McLaren Artura – Battery Charging Guide Label Addition

Bulletin type: Service Campaign
Reference number: N/A
Campaign reference: SCB 16 M 002
Attention: Retailer Aftersales Managers,
Retailer Service Managers, Retailer Service Advisors,
Retailer Technicians, Retailer Parts Managers
Affected vehicles: McLaren Artura
Situation: Installation of battery charging guide label
Procedure: Action affected vehicles during next Retailer visit. Please refer to the information outlined in this document to complete the required work
Date: 10 October 2023

Image 1 Label example

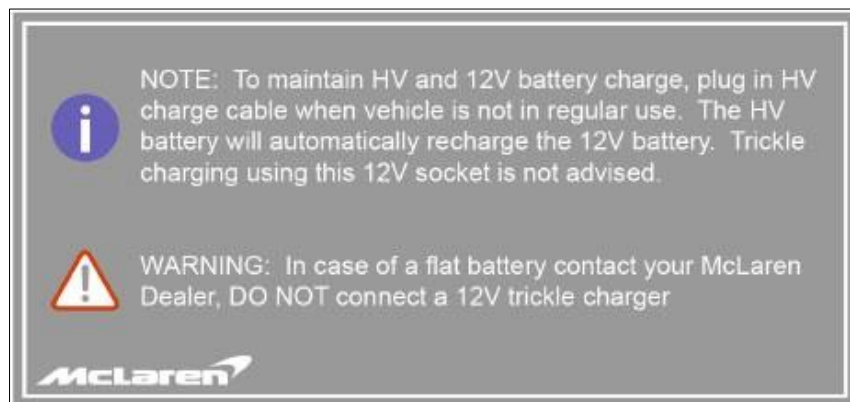
Through continuous product quality monitoring, McLaren Automotive has released a label with battery charging care points to maintain optimal battery life.

Image 2 Label application area (1)

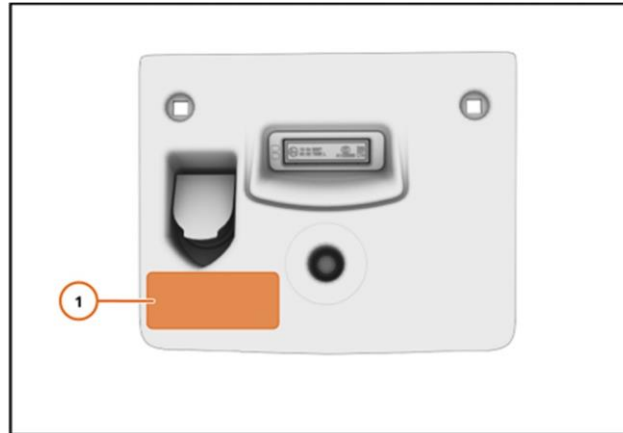
Identify the label application area. The label application area is at the bottom left corner of the front luggage bin hatch cover

Prepare the highlighted area. Use Betaclean 3900 to clean the surface. Allow 90 seconds for drying

Apply even pressure to adhere the label to the luggage bin hatch cover bottom left corner as shown above. Ensure the label is straight and with no air bubbles or creases.
